RE: Response to Comments and Transmittal of Site Specific Work Plan Addendum No. 1, Revision 1
Green Bay Former Manufactured Gas Plant
Green Bay, Wisconsin
Wisconsin Public Service Corporation
CERCLA Docket No. V-W-06-C-847, CERCLIS ID – WIN000509948

To: Glenn Luke – WEC Energy Group
From: Abby Small and Staci Goetz – Ramboll
cc: Frank Dombrowski - WEC Energy Group
Re: Site Specific Work Plan Addendum No. 1, Revision 1
Green Bay Former Manufactured Gas Plant, Green Bay, Wisconsin
Wisconsin Public Service Corporation

FIGURE 5

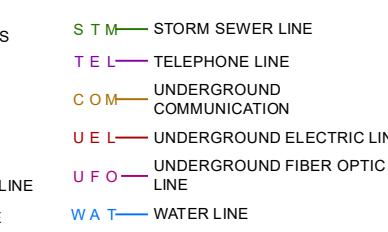
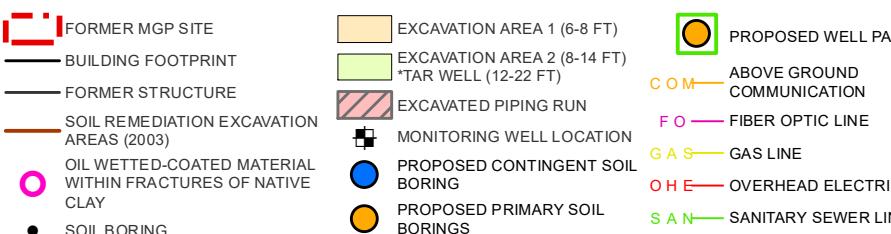
3. *Soil Boring Locations, Page 7: Consideration should be given to an additional step out location southeast of proposed boring SB-718. If SB-718 shows impacts, an additional soil boring at the southeast corner of the intersection of N. Madison and Elm would be required to achieve a lateral delineation in this area.*

WPSC Response: Upon further review of utilities in the southeast corner of the parking lot, the location of boring SB-718 has been moved into the roadway to allow for appropriate utility offsets for the safe installation of the boring. Further, WPSC acknowledges that if impacts are identified at SB-718, additional step-out boring(s) would be needed. However, the utility network is dense at this intersection, and WPSC does not own the parcels to the south and east of the roadways. Access agreement(s) would need to be negotiated to install borings on those parcels. WPSC intends to proceed with the initial boring in the roadway. If contingent borings are required, USEPA will be notified, and access agreements will be negotiated at that time. Installation of contingent boring(s), if necessary, will be performed as part of a second drilling mobilization.

Note that minor adjustments were made to the location of two other borings (SB-716 and SB-717) between Revision 0 and Revision 1 due to a refined understanding of the utilities in N. Madison Street. Minor adjustments were also made to the location of borings SB-708, SB-710, and SB-713 between Revision 0 and Revision 1 so that the borings are installed on WPSC-owned property and not on third-party (Harbinger Corporation) property. Installation on WPSC-owned property reduces installation constraints, including work hours and restoration requirements imposed by the third-party property owner. Boring locations may be field modified as needed based on the field-identified locations of utilities.
